## **ADDENDUM NO. 2**

Issued: October 25, 2016

Project: Joplin Early Childhood Center  
Site Legal Description:  
JOP MISC  
BEG 1360.93' S & 50' E NW  
COR SE E 456.91' N 318.78'  
W 456.91' S 318.78' TO POB

Project No. 16054

**C106**

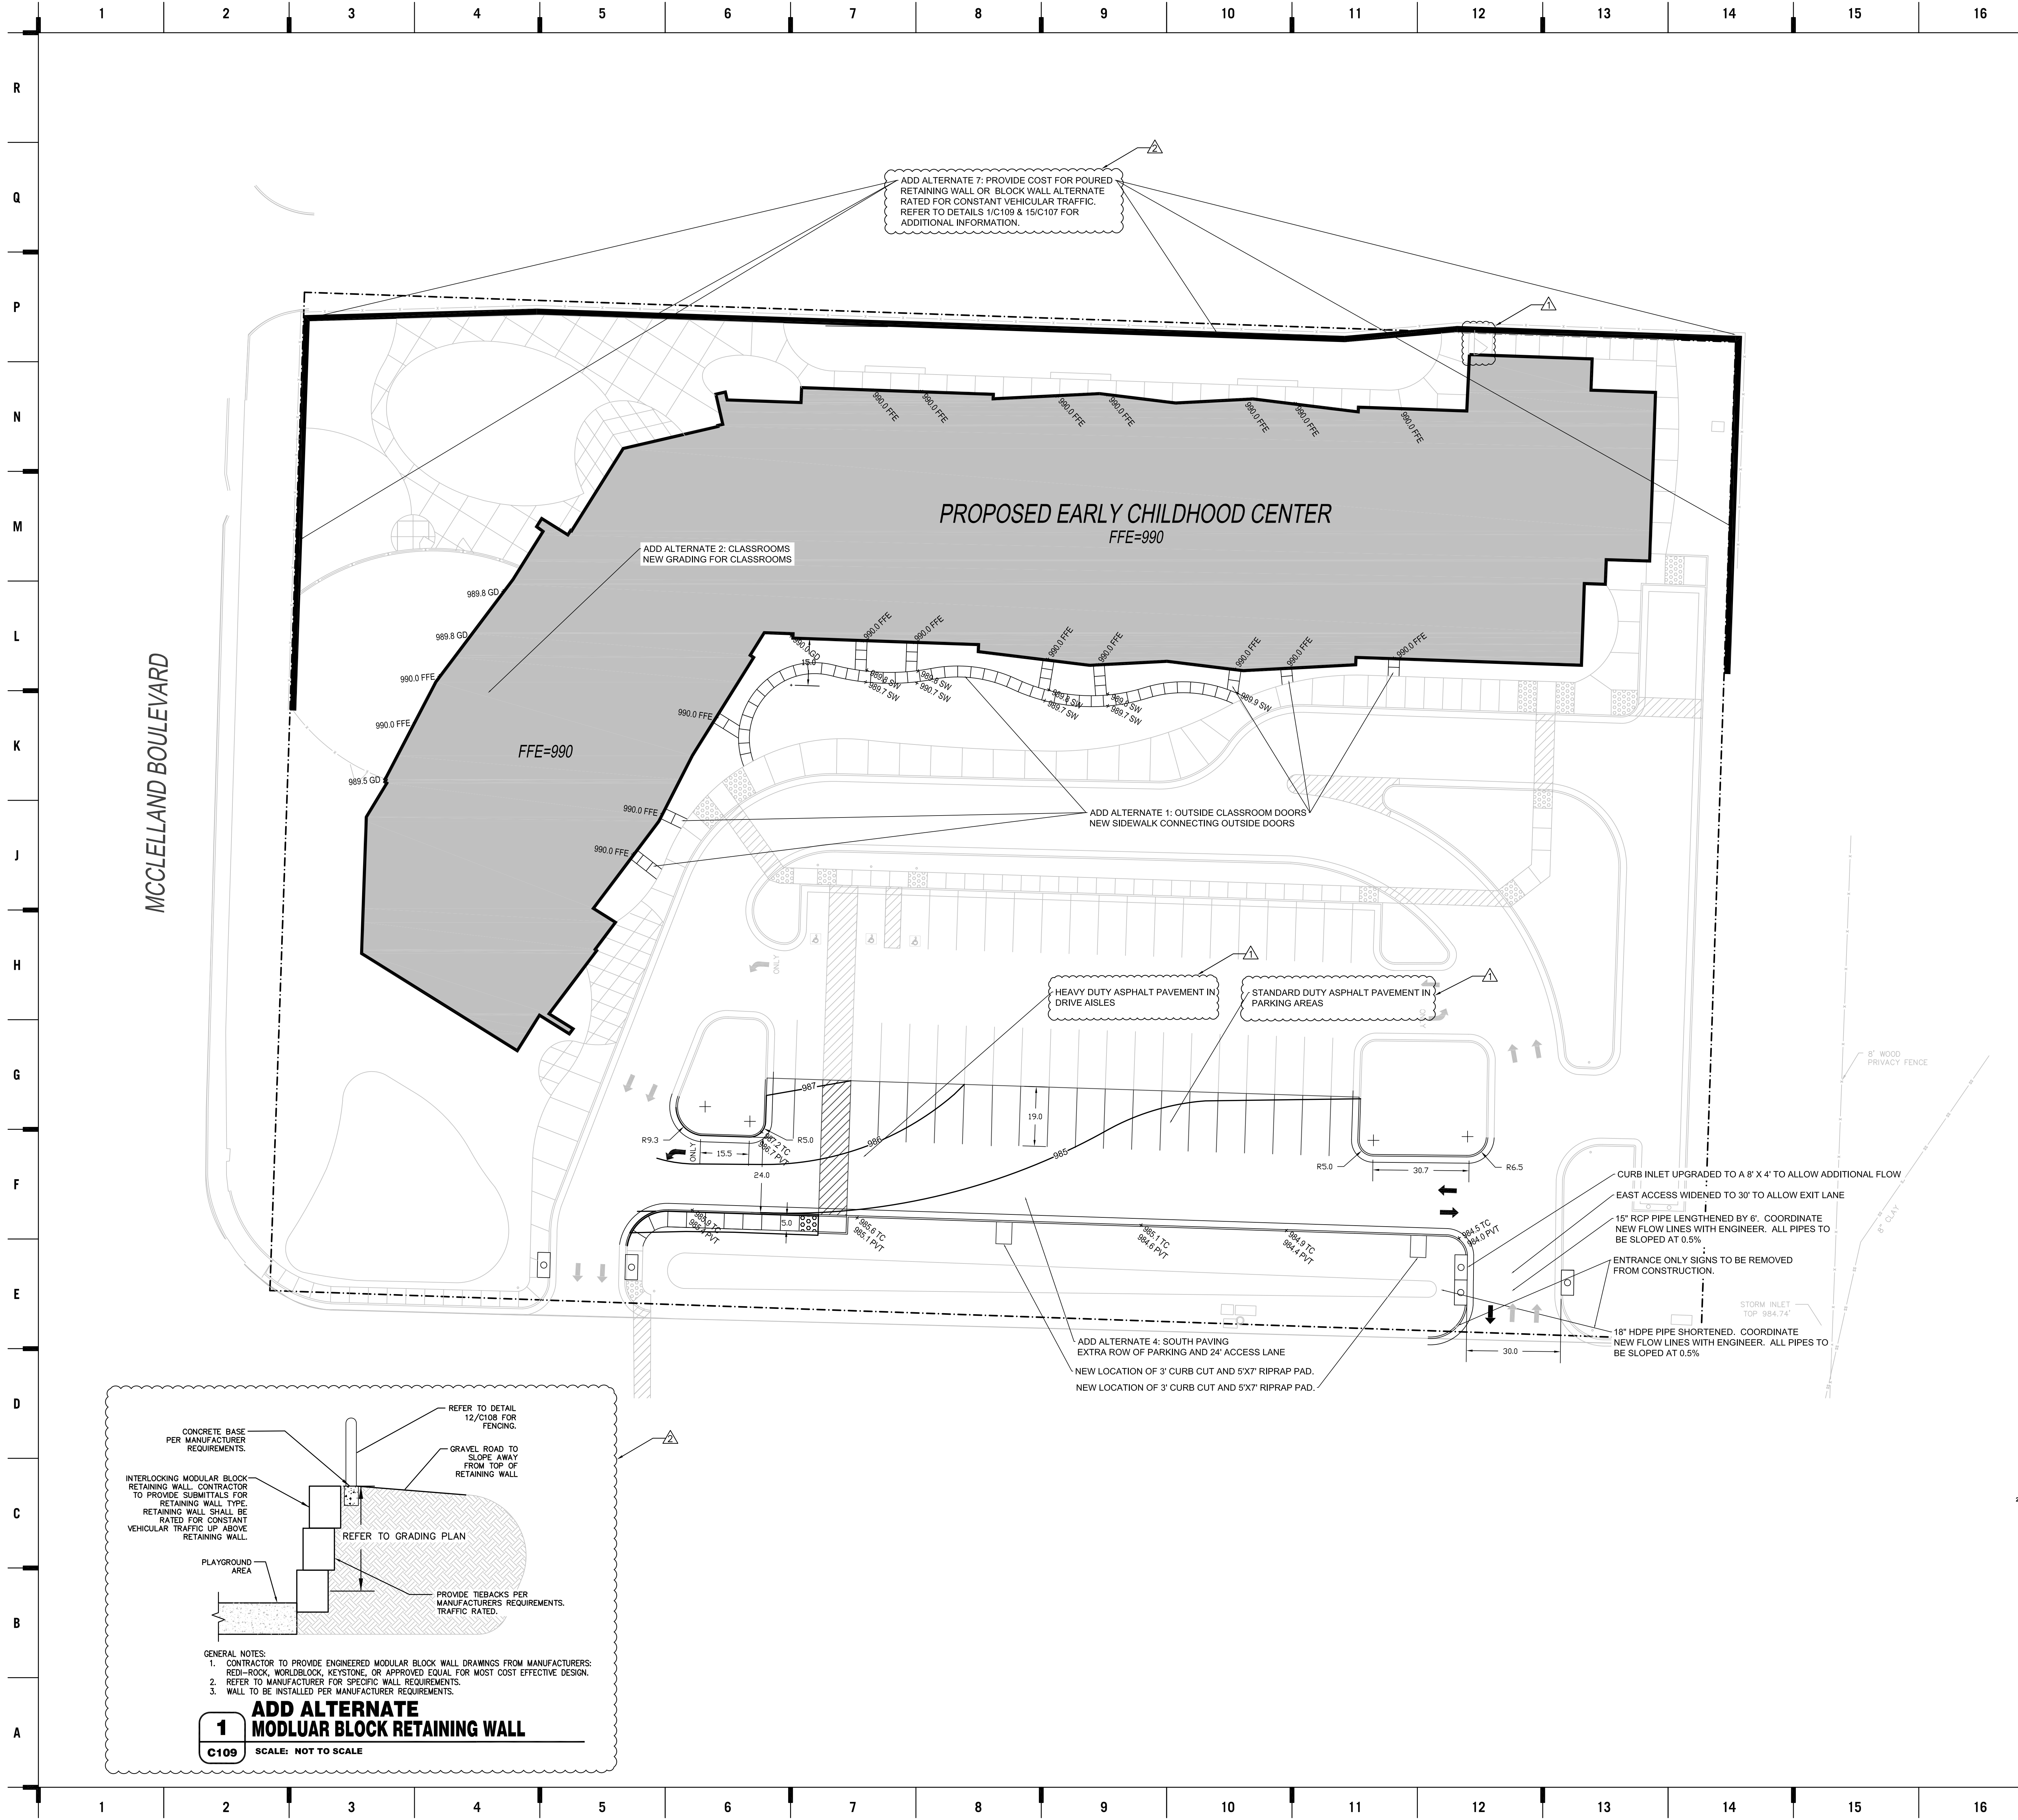
**G46 QUESTION: THERE IS A GREASE TRAP INDICATED ON SHEET C106. THE PLANS SAY REFER TO MECHANICAL PLANS FOR SIZE REQUIREMENTS, BUT MECHANICAL PLANS DO NOT HAVE SIZE REQUIREMENTS FOR GREASE TRAP. WHAT IS THE SIZE OF THE GREASE TRAP?**

G46.1 Answer: The grease trap is no longer included in the project and has been removed from sheet C106. The grease trap will be installed at a later date when a commercial dishwasher is added to the kitchen/receiving area.

**A101B**  
OF

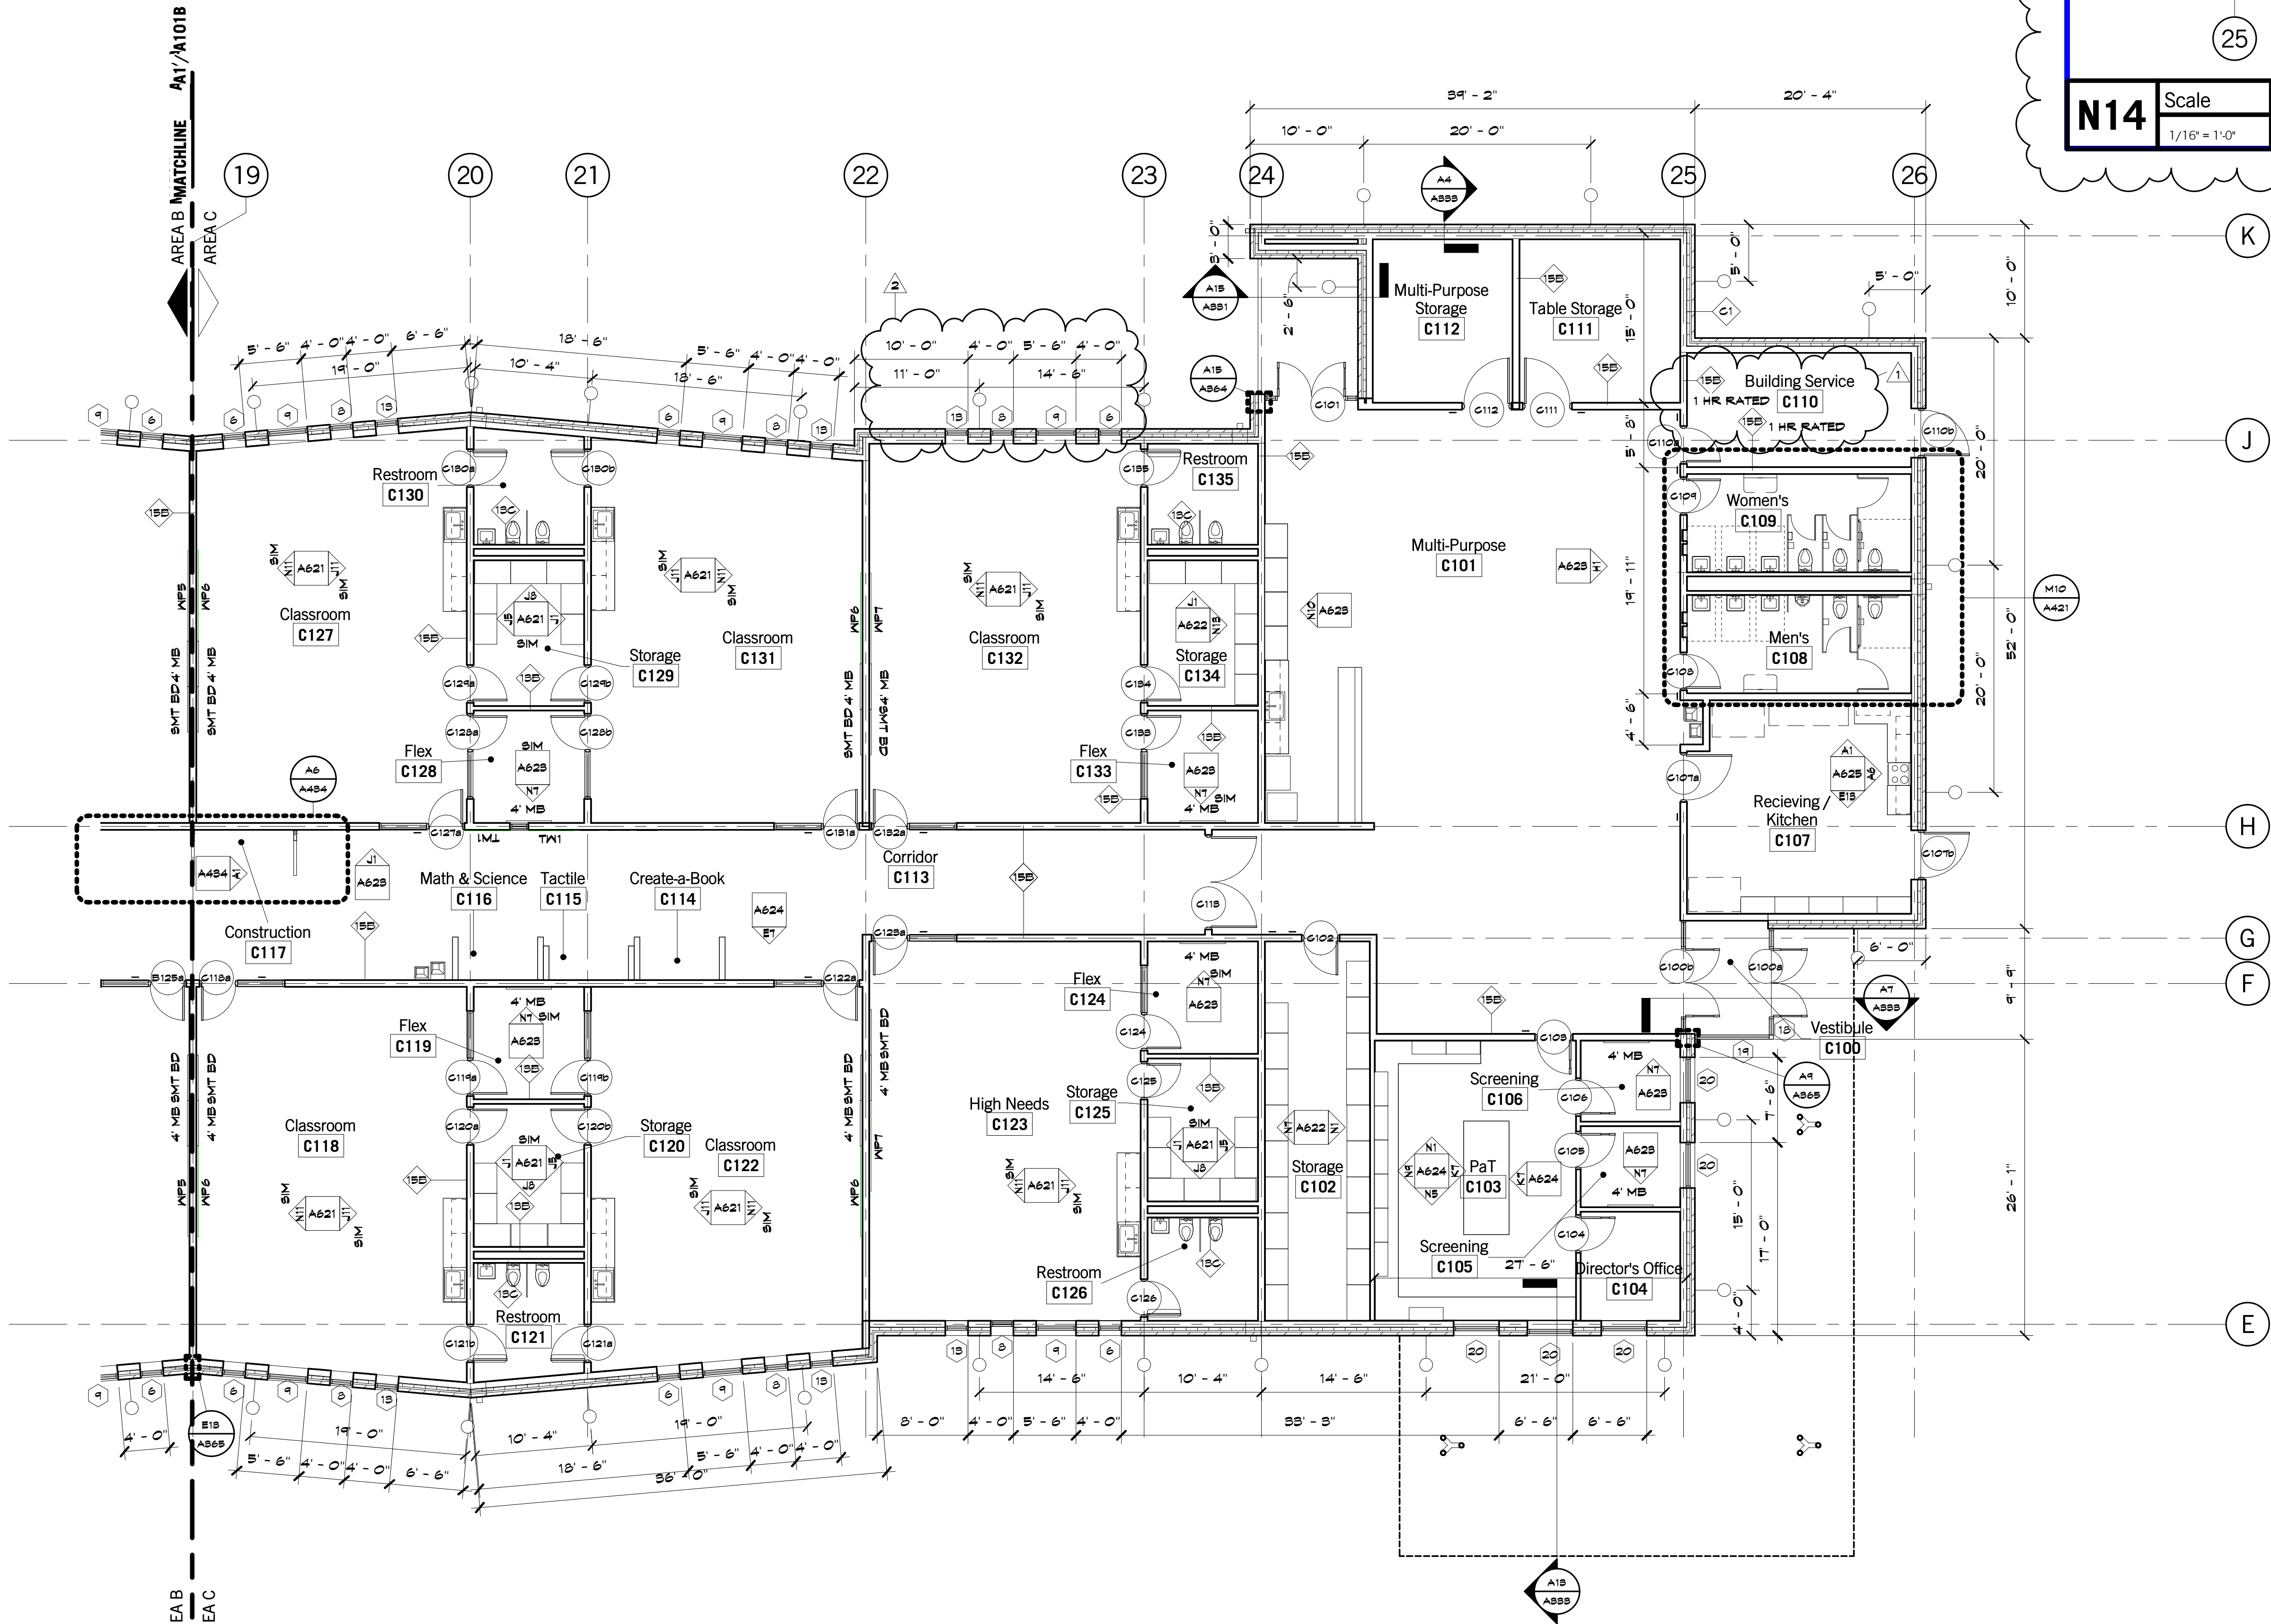
A19.1 REPLACE previously issued Sheet A101B in Addendum 1, with attached sheet A101B dated 10.25.2016. (Clarify clear story window locations and types).
